# UNITED STATES PATENT AND TRADEMARK OFFICE

APPLICATION NO.	FILING DATE	FIRST NAMED INVENTOR	ATTORNEY DOCKET NO.	CONFIRMATION NO.
10/042,829	01/08/2002	Chi Wah Cheng	P/4076-10	7316

**Office Action Summary**

**FIG. 4**

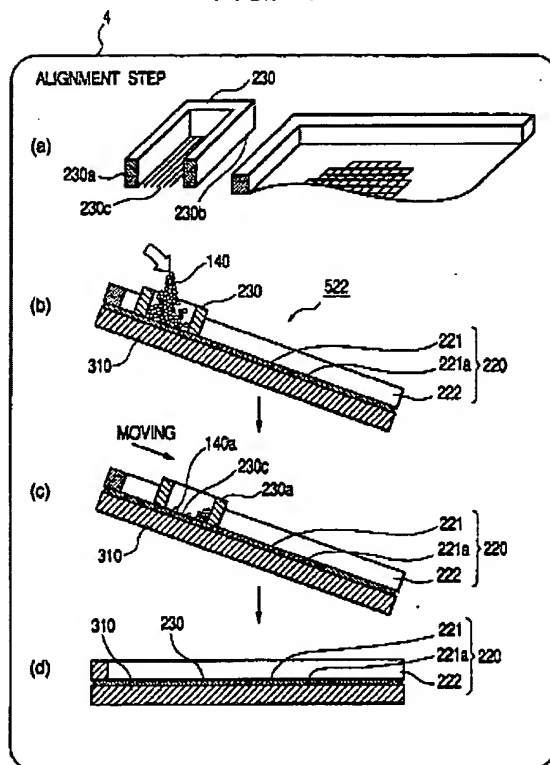
Ooroku et al. teaches a guide member which is configured to direct the solder balls to positions corresponding to the array of positions the solder balls are to take up on the substrate (Figures 4-6, specifically #220, 221, 221a and 222); a container for a plurality of solder balls, the container being movable between a first position remote from the guide member and a second positioned directly in communication with the guide member (Figures 4-6, specifically #230); a mechanism configured to apply a force to the solder balls in the container in the direction of movement of the container as the container moves between the first position to the second position (Figures 4-6). On page 4, lines 5-9 and page 7, lines 1-19 of the specification the applicant uses a gravitational force and the force generated by the walls of the container during movement to bias the solder balls in the direction of movement of the container. The mechanism that Ooroku et al. uses to move the container #230 applies force to the solder balls through both gravity and the side walls of the container #230.

Figure 4 also teaches tilting means adapted to rotate the container about an axis perpendicular to the direction of motion of the container to thereby tilt it. The mechanism used to tilt the container of Ooroku et al. is capable of rotating the container and the positioning means a plurality of times when the container is in position directly over the positioning means.

capture solder balls with in the template, and wherein the plurality of apertures are arranged in an order similar to the array positions comprising solder pads on the substrate; solder balls captured in the plurality of apertures are removable by a pick-and-place device while retaining their respective positions, and places onto corresponding positions of solder pads on the substrate; means to rotate the container, ball template and substrate simultaneously; the apertures comprises through-holes which allow solder balls to fall through the ball template directly onto a substrate placed below it (Figures 4-6).

**FIG. 9*****Claim Rejections - 35 USC § 103***

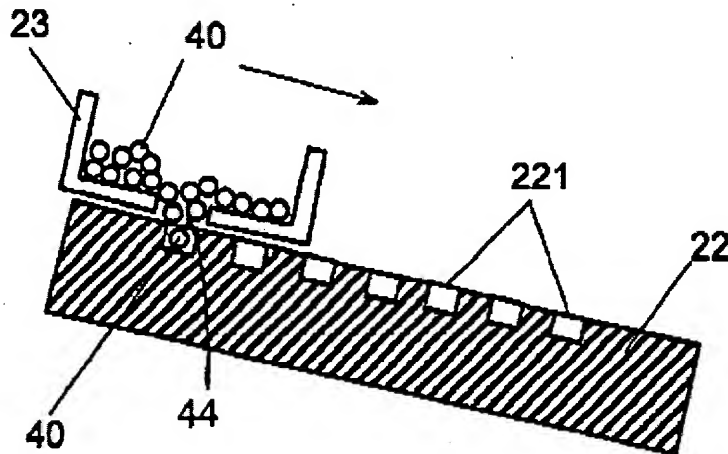
Kasai et al. teaches a guide member which is configured to direct the solder balls to positions corresponding to the array of positions the solder balls are to take up on the

substrate (Figure 9, specifically #22); a container for a plurality of solder balls, the container being movable between a first position remote from the guide member and a second positioned directly in communication with the guide member (Figure 9, specifically #23); a mechanism configured to apply a force to the solder balls in the container in the direction of movement of the container as the container moves between the first position to the second position (Figure 9). On page 4, lines 5-9 and page 7, lines 1-19 of the specification the applicant uses a gravitational force and the force generated by the walls of the container during movement to bias the solder balls in the direction of movement of the container. The mechanism that Kasai et al. uses to move the container #23 applies force to the solder balls through both gravity and the side walls of the container #23. Figure 9 also teaches tilting means adapted to rotate the container about an axis perpendicular to the direction of motion of the container to thereby tilt it. The mechanism used to tilt the container of Kasai et al. is capable of rotating the container and the positioning means a plurality of times when the container is in position directly over the positioning means.

capture solder balls within the template, and wherein the plurality of apertures are arranged in an order similar to the array positions comprising solder pads on the substrate; solder balls captured in the plurality of apertures are removable by a pick-and-place device while retaining their respective positions, and places onto corresponding positions of solder pads on the substrate; means to rotate the container, ball template and substrate simultaneously; the apertures comprises through-holes which allow solder balls to fall through the ball template directly onto a substrate placed below it (Figures 6A-B and 9).
